November 17, 2017

Re: **2017 Addendum to Water Quality Permit, Rosemont Copper Project ACOE Application No. SPL – 2008-00816-MB**

Figure 1. In red, areas of former mine-related activities based on cultural resource surveys. Drill holes in yellow. Location of stock tank removals shown in green and are approximate.

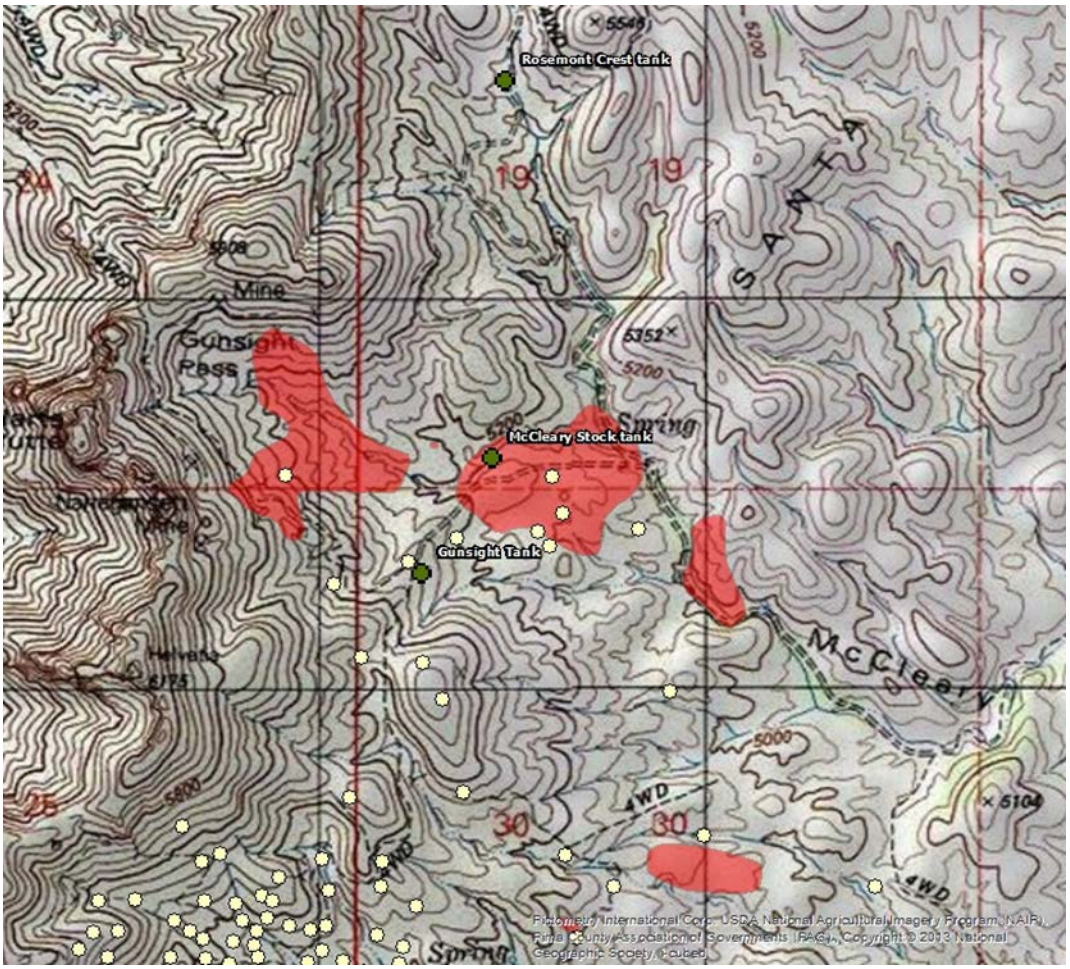
Rosemont is proposing to eliminate four dirt tanks within the project footprint to allow stormflow to be conveyed downstream. In two of the watersheds (McCleary Stock Tank and Gunsight Tank) there has been historical mining activities (see map below; red areas are historic mining sites as determined from cultural resource surveys and yellow dots are historical drill holes). The impact of disturbing soils associated with these features and conveying unknown—and unanalyzed—contaminants downstream has not been analyzed as part of the Biological Opinion or FEIS.

ADEQ must investigate the possibility that past mine-related activities have contributed to pollution in groundwater or surface water emanating from McCleary Canyon and are now detectable in stormwater, prior to issuing a certification to renew mining.

Figure 3. Peak and base flows in July and August 2017 at USGS gage 09484580. Base flows persisted long after the last measured rain at the gage (August 3, August 15).

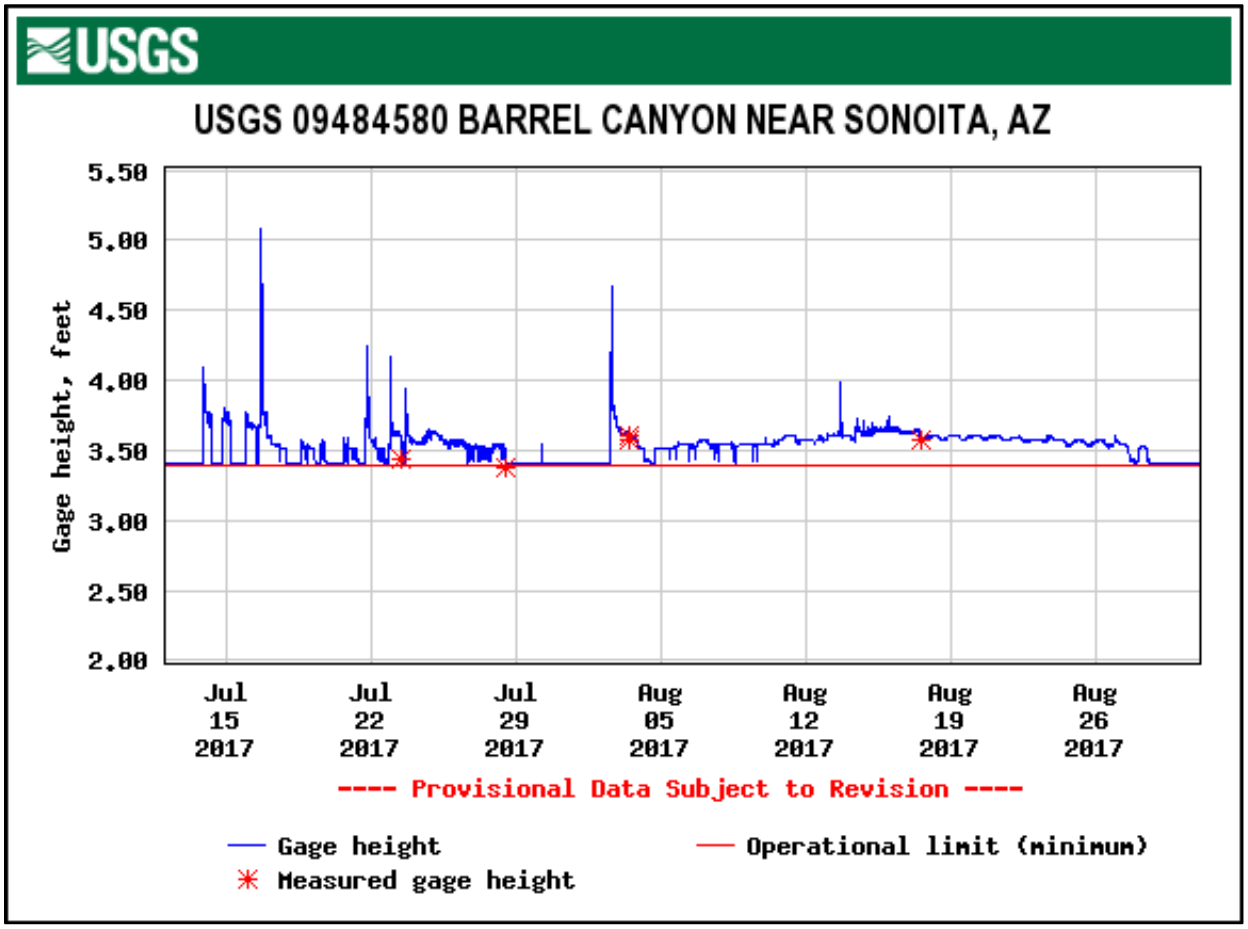
Barrel Canyon also has intermittent reaches downstream of the mine. Despite recent drought, the U. S. Geological Survey (USGS) data collection at USGS gage #09484580, located at a culvert under Highway 83, upstream of "Barrel Spring" shows evidence of intermittent flows (Figure 3). The gage is located at a point within the previously documented PAG-mapped intermittent flow reach. USGS staff periodically visit the stream gage to perform maintenance, and rate the accuracy of flow measurements. During their visits, they document actual stream flow conditions using direct measurement of flow and visual observations.
The gage record for the 2017 monsoon season shows two periods with base flows for a number of consecutive days in July and August, shown in the graph below. Red asterisks indicate the date of field observations at the gage by USGS personnel. Storm flows are shown by the sharp rises with a "tail", and the base flows by the relatively stable low flows in between the peaks.

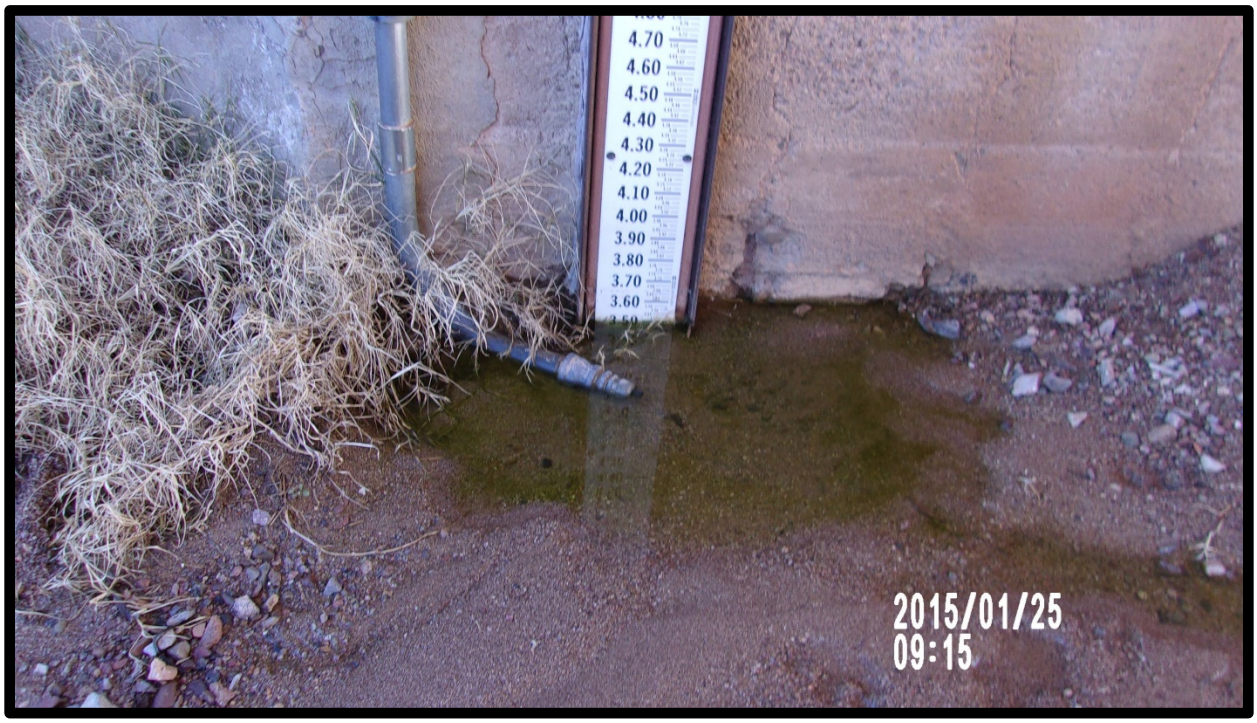
A shallow water table appears to help sustain flows in this intermittent reach. Figure 5 shows bedrock exposures which help to bring groundwater to the surface. Repeated groundwater level measurements have been provided to the Forest Service by Hudbay (2015; Memorandum from Kathy Arnold to Karen Herther, "Water Quality/Water Level data for U. S. Forest Service") both upstream and downstream of the gage. Downstream of the gage, an unnamed well (D-18-16-14dac) shows measurements that fluctuated flow less than one to more than ten feet below land surface over the period 2008 to 2014. Upstream of the gage, groundwater levels in a monitoring well installed by Rosemont (located at D18-16-15dcc) fluctuated from two to three feet below land surface during 2013 and 2014. There is also a recorded spring downstream of the gage, called Barrel Spring.
